CITY OF OWOSSO PLANNING COMMISSION
Regular Meeting
Monday, June 22, 2026 at 6:30 p.m.
AGENDA

Planning Commission
 City of Owosso
 301 W Main Street
 Owosso, MI 48867

Subject: **1000 Bradley Site Plan Review.** Located at the northeast corner of Beehler and S. Lyon Streets, with access to Bradley Street from the south. The southwest side of the property abuts a railroad line and is therefore not accessible from that direction. The property includes approximately 6 acres and is zoned RM, Residential.

SHEET NUMBER:
AS-100

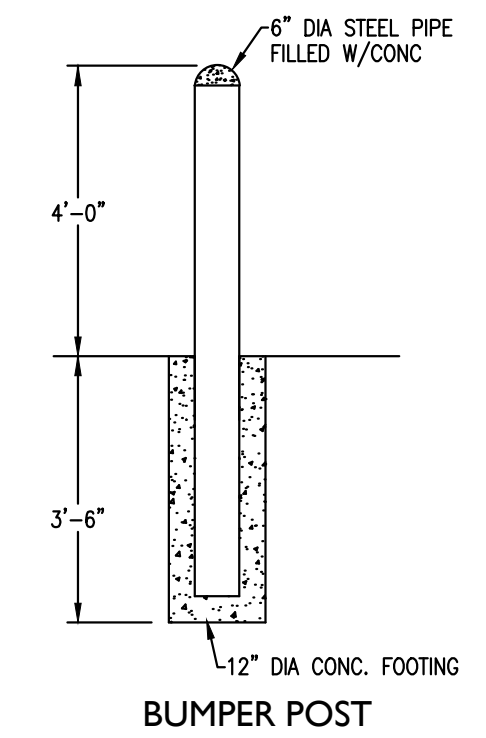
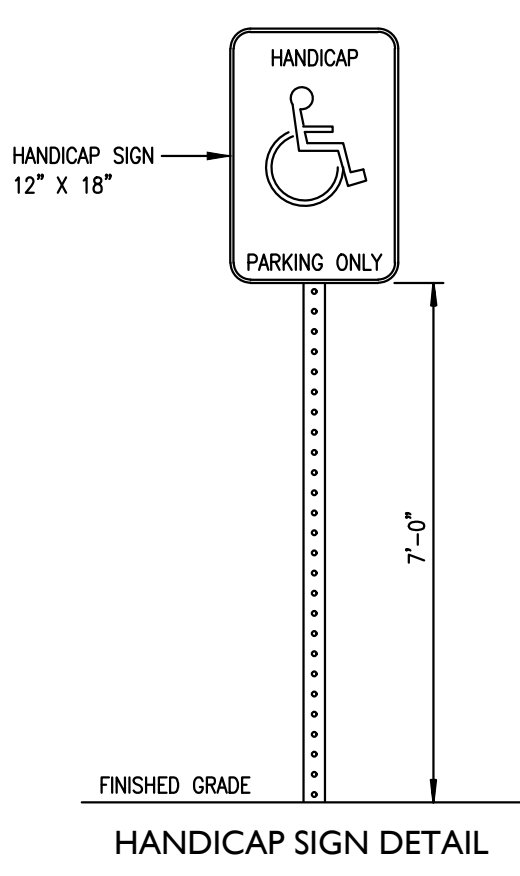
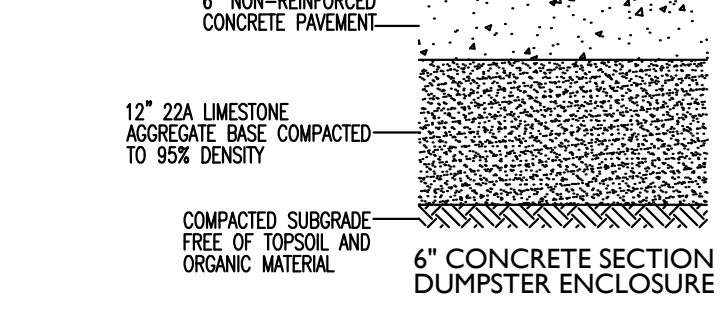
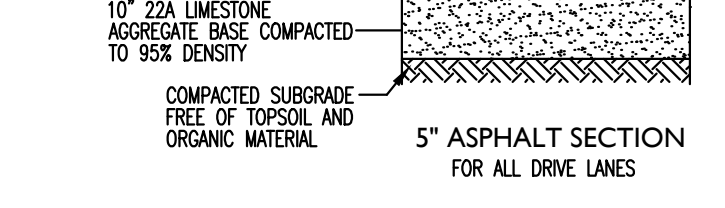
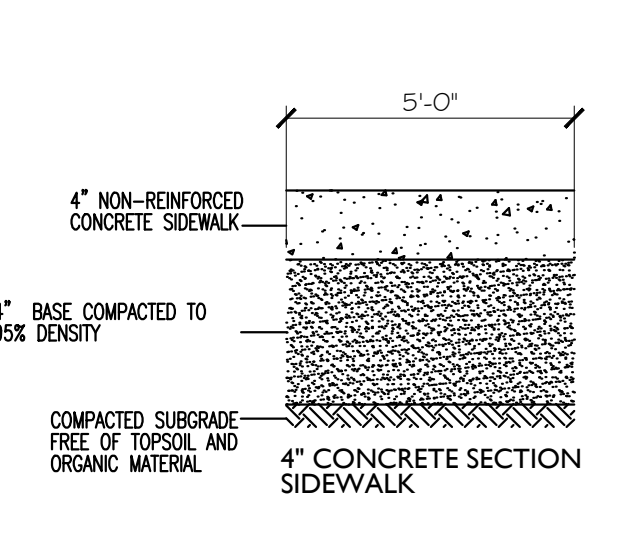
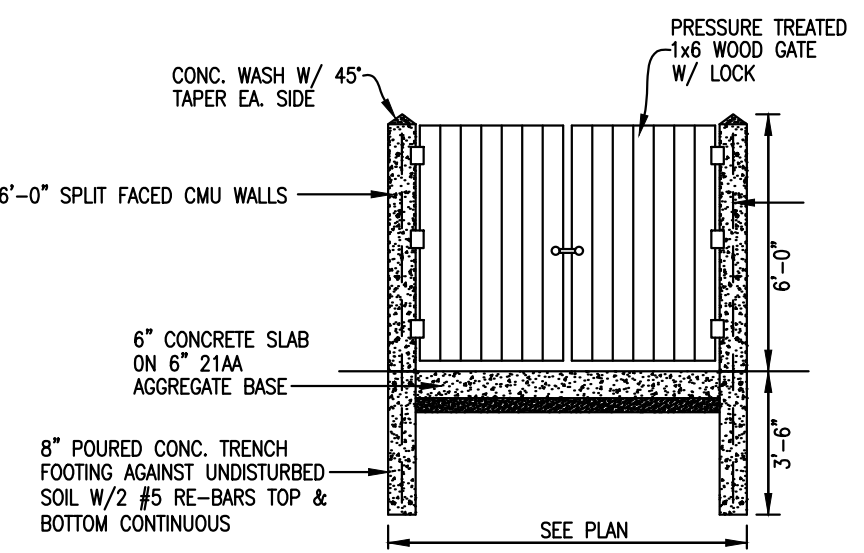
| Outdoor amenity area | 10% | Not provided | Potentially in compliance. <u>There may be enough room next to unit 31 to provide an outdoor amenity.</u> |
| Principal Building | 2 stories minimum | Additional information needed. | Potentially in compliance. <u>Although this requirement appears to be met, dimensions are needed.</u> |

| | Required | Provided | Comments |
|---|-------------------------|--|--|
| Barrier-free Spaces | 3 | 2 | Potentially in compliance. 1 barrier-free space is required per 25 spaces or fraction thereof. |

| | Required | Provided | Comments |
|--|----------|----------|-------------------|
| Two-Way Aisle Width (Secondary Lots, double loaded) | 26' | 24' | Not in compliance |

4. **Sidewalks.** The following changes should be considered by the Planning Commission: (1) all sidewalks abutting parking spaces should be a minimum seven (7) feet wide to accommodate vehicle overhang; and (2) additional sidewalk connections are needed from the parking lots to units #18, 20, 22, and 24.

1. The addition of an outdoor amenity meeting ordinance requirements;
2. Submission of measurements regarding building height;
3. The addition of one (1) barrier-free parking space;
4. The width of the drive lanes for the two (2) end parking lots be increased to 26’;
5. Planning Commission acceptance of the proposed greenbelts along Beehler and Lyon Streets;
6. The addition of appropriate landscaping for the proposed bioswales;
7. Changes to the sidewalks identified under item #4 above;

SHEET NUMBER:
LP-100

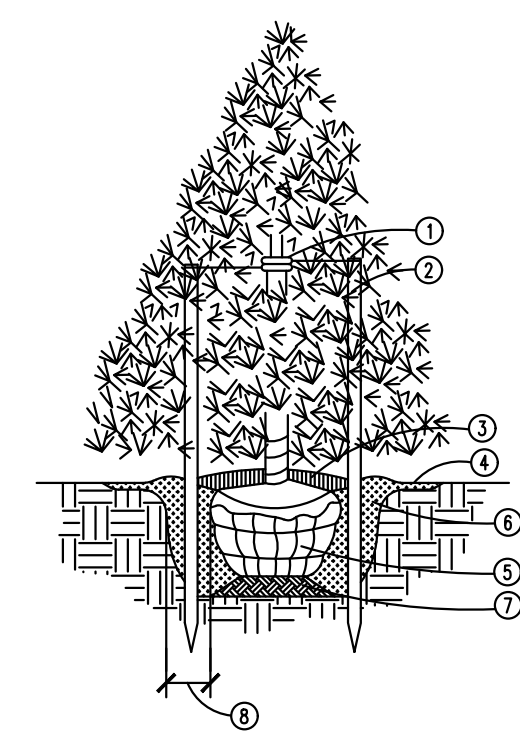
3. **Landscaping.** The proposed landscape plan was reviewed in accordance with *Article XVII, Landscape Standards and Tree Replacement*, as described in the following table. In addition, the site plan shows the presence of two (2) bio swales but landscaping is not shown indicating such.

| | Required | Provided | Comments |
|----------------------------|---|--|---|
| Greenbelt (Lyon Street) | 35' wide 1 canopy tree + 6 shrubs per 30 liner feet of street frontage -- 480' linear street frontage = 16 canopy trees + 96 shrubs | 20' wide 21 canopy trees + 84 shrubs | Potentially in compliance <u>The applicant used the calculations for a "Buffer B", indicating that site limitations prevent use of the 35' greenbelt requirements. Since this is an "urban" site, the 35' greenbelt seems excessive and is more appropriate for a suburban location. Section 38-216(g), Greenbelts, gives the Planning Commission the ability to vary the requirements when the intent of the ordinance is met.</u> |
| Greenbelt (Beehler Street) | 35' wide 1 canopy tree + 6 shrubs per 30 liner feet of street frontage -- 506' linear street frontage = 17 canopy trees + 102 shrubs | 20' wide 26 canopy trees + 116 shrubs | Potentially in compliance <u>The applicant used the calculations for a "Buffer B", indicating that site limitations prevent use of the 35' greenbelt requirements. Since this is an "urban" site, the 35' greenbelt seems excessive and is more appropriate for a suburban location. Section 38-216(g), Greenbelts, gives the Planning Commission the ability to vary the requirements when the intent of the ordinance is met.</u> |

Plan View
Scale - 1" = 30ft

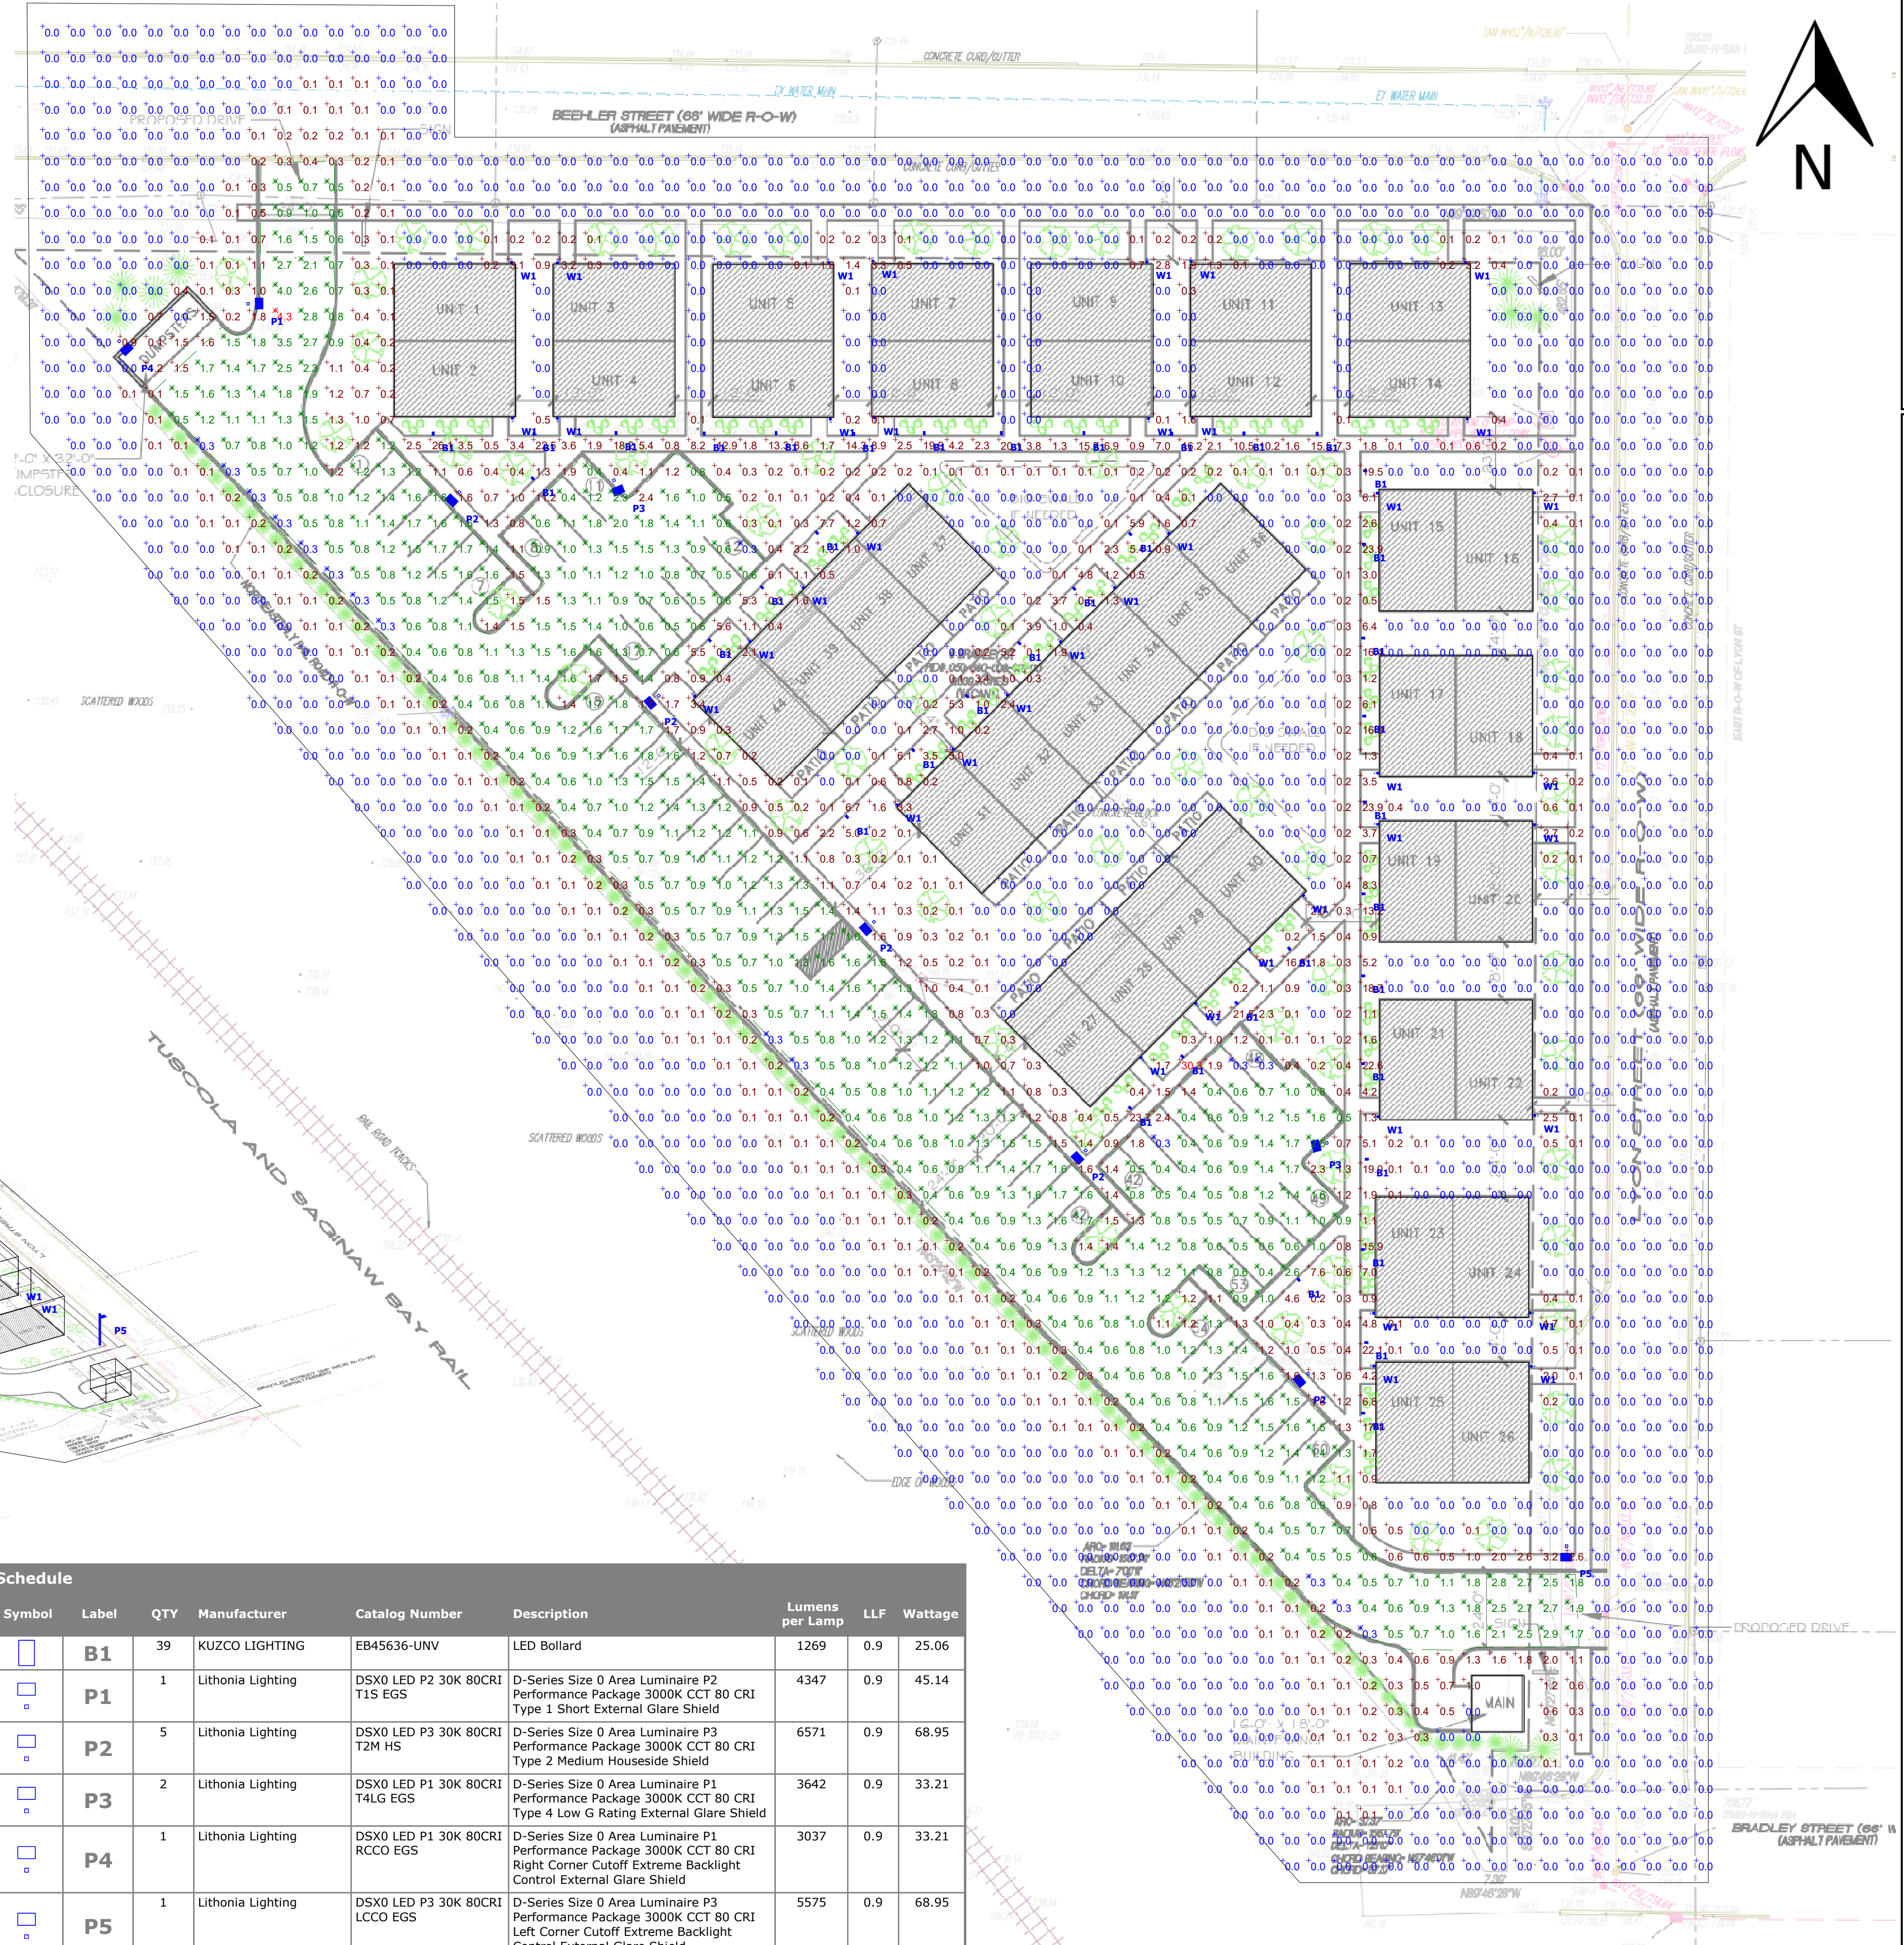
5. **Lighting.** The lighting plan indicates that there are locations where the maximum 10 footcandles is exceeded and others where it is too dark, like along the Beehler and Lyon Street frontages. Adjustments should be made to the plan to provide more even distribution of light throughout the site.

8. Submission of a revised lighting plan, meeting ordinance requirements, for administrative review and approval;
9. Planning Commission acceptable of the proposed building design; and
10. Review and approval by the appropriate city departments, consultants, and agencies prior to the issuance of a building permit.
